**Construct New Boiler Plant**  
**Solicitation No. VA244-15-R-0124**  
**Contractor Questions/Clarifications**

PROJECT:  
Construct a New Boiler Plant for the  
Wilkes-Barre VA Medical Center

PROJECT #: 693-11-128

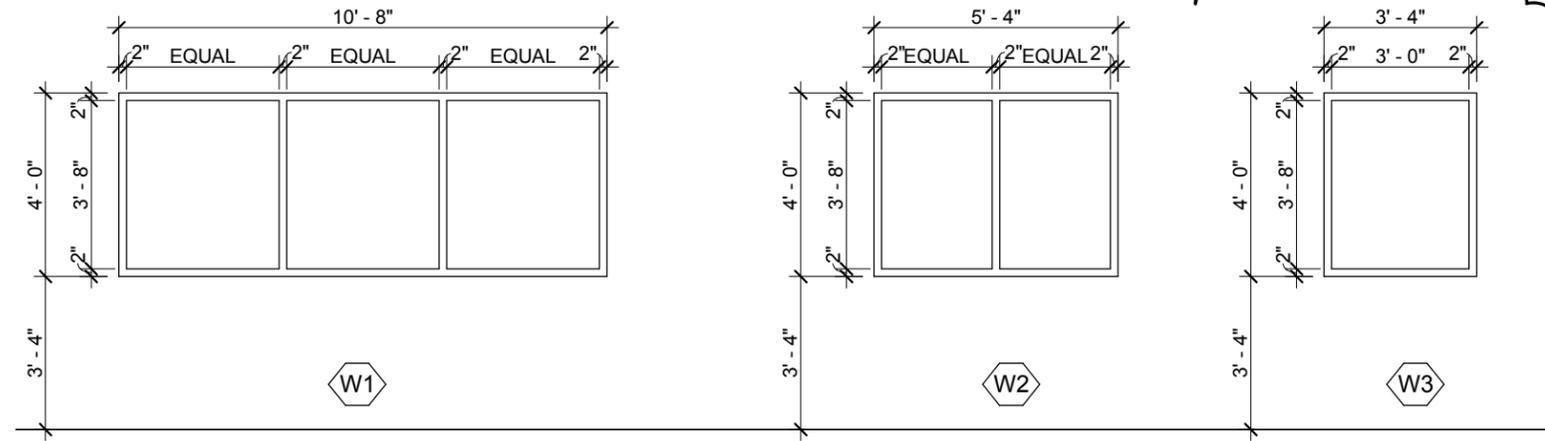
- 11) There are a few problems with the selection of equipment as follows:

- a. PRV Stations – Four of the PRV stations have pressure reductions greater than 10:1. Mechanical valves sized with a turndown greater than 10 to 1 will hunt thus they will provide unstable pressures and ultimately valve life will be shortened.
- b. Automatic Pump Trap – One APT10-4.5 has been selected for all three boiler mud drums. There are two problems with this design. First, the APT10-4.5 is not capable of pumping this condensate load. Second, one ATP must be installed for each mud drum; you cannot combine multiple loads into a common pump trap.

*Response:*

1. *Contractors shall provide a two-stage pressure-reducing station with 1/3-2/3 valve with capacities. The new PRV will be called PRV 5A and 5B. The first stage will reduce pressure from 125 psig to 50 psig, and serve both PRV1 and PRV2. Revise schedule as follows:*

- *PRV-1A 3550 lbm/hr 50 psig in 6 psig out. Basis of design is Spirax 25P.*
  - *PRV-1B 1750 lbm/hr 50 psig in 8 psig out. Basis of design is Spirax 25P.*

- *PRV-2A 3730 lbm/hr 50 psig in 8 psig out. Basis of design is Spirax 25P.*
  - *PRV-2B 1870 lbm/hr 50 psig in 10 psig out. Basis of design is Spirax 25P.*

- *PRV-5A 5900 lbm/hr 125 psig in 50 psig out. Basis of design is Spirax 25P.*
  - *PRV-5B 3700 lbm/hr 125 psig in 50 psig out. Basis of design is Spirax 25P.*

- *NOTE: All PRVs to be Class 150 with cast steel bodies. Size relief valve for full open valve failure. Revise size of SV-007 and SV-010 so their capacity meets or exceeds the capacity of the respective PRV stations provided. PRV-5 does not require a safety valve, as all piping and components are rated for 150 psig.*

2. *Revise Safety Valve Schedule as follows:*
  - *SV-007 LPS Line to DA 15 psig at 250 F 6000 lbm/hr\**
  - *SV-008A Deaerator Sentinel Valve 10 psig at 250 F 1000 lbm/hr*

- *SV-008B Deaerator Safety Valve 15 psig at 250 F 6000 lbm/hr\* (new valve)*

3. *Revise Boiler Feed Pumps Schedule so that all feed pumps have a capacity of 50 gpm at 408 ft. Motor horsepower shall remain the same.*
4. *Deaerator tank shall be 2000 gallons as scheduled; however, the maximum throughput shall be 54,000 lbm/hr, not 36,000 lbm/hr.*
5. *Pumping traps are not needed. Delete pump traps from boiler drum coils. Install completed trap assembly with inverted bucket trap for each boiler drum. Collect pipes to common point and route to condensate surge tank.*

CONSTRUCTION SKETCH  
**CS-A001**

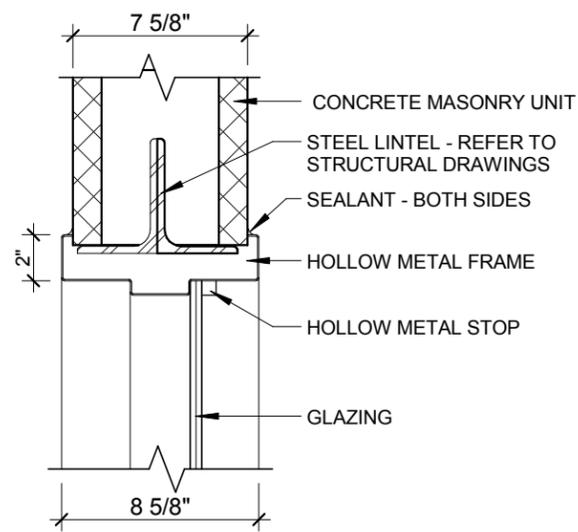
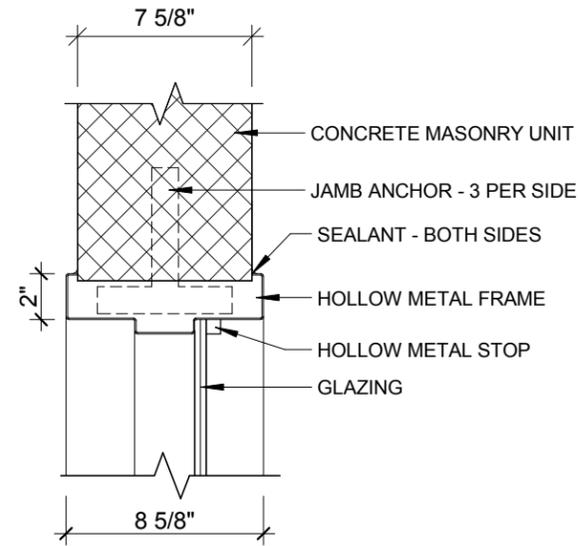
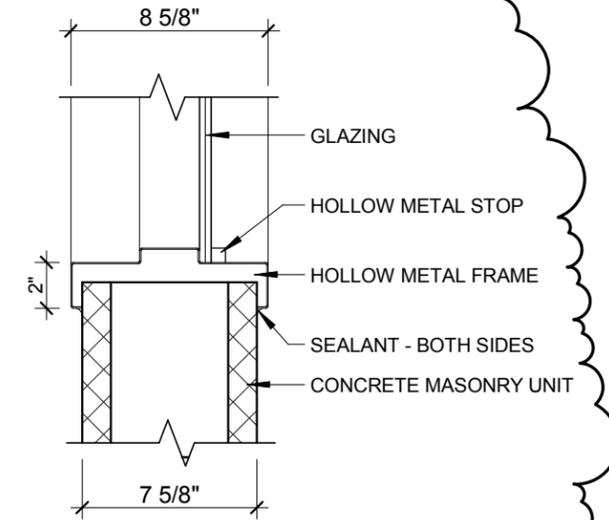
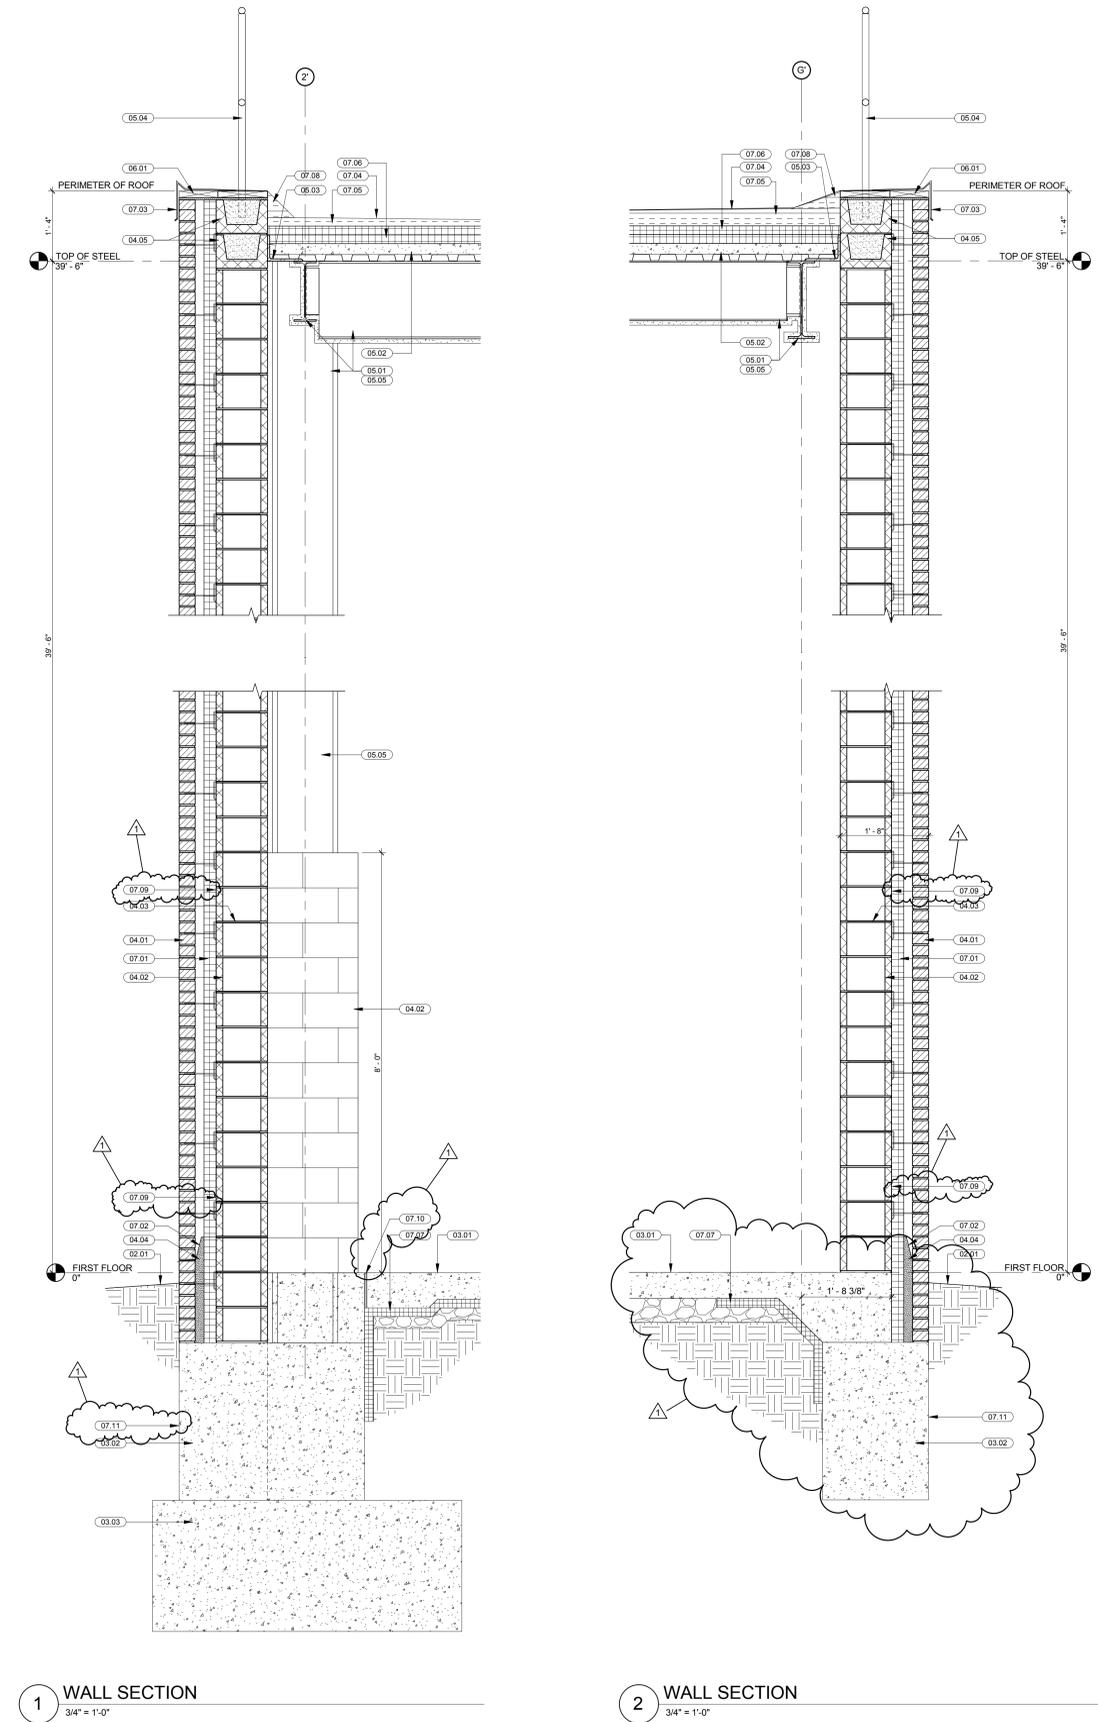
- 4) Where are metal studs and GWB required on the project, as specified? Not depicted anywhere.

*Response: See attached Sketch CS-A001 that is calling out CMU walls at the control room. There are no metal studs with GWB on the project.*

Project Number 693-11-128
Building Number -
Drawing Number A301
Dwg. 34 of 93

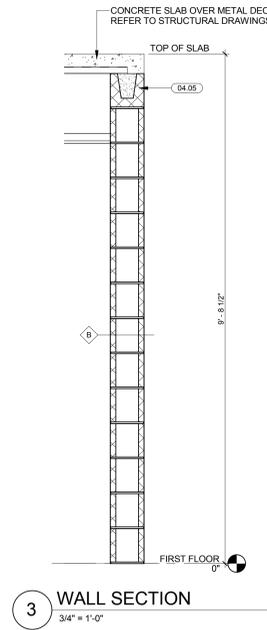
- 8) Please clarify the intended locations for waterproofing versus damp proofing. Each is specified yet the related locations for each system are not clearly defined.

*Response: Please see revised drawing A301 dated 5/18/2015 showing “dampproofing” and “Air/Vapor barrier.”*
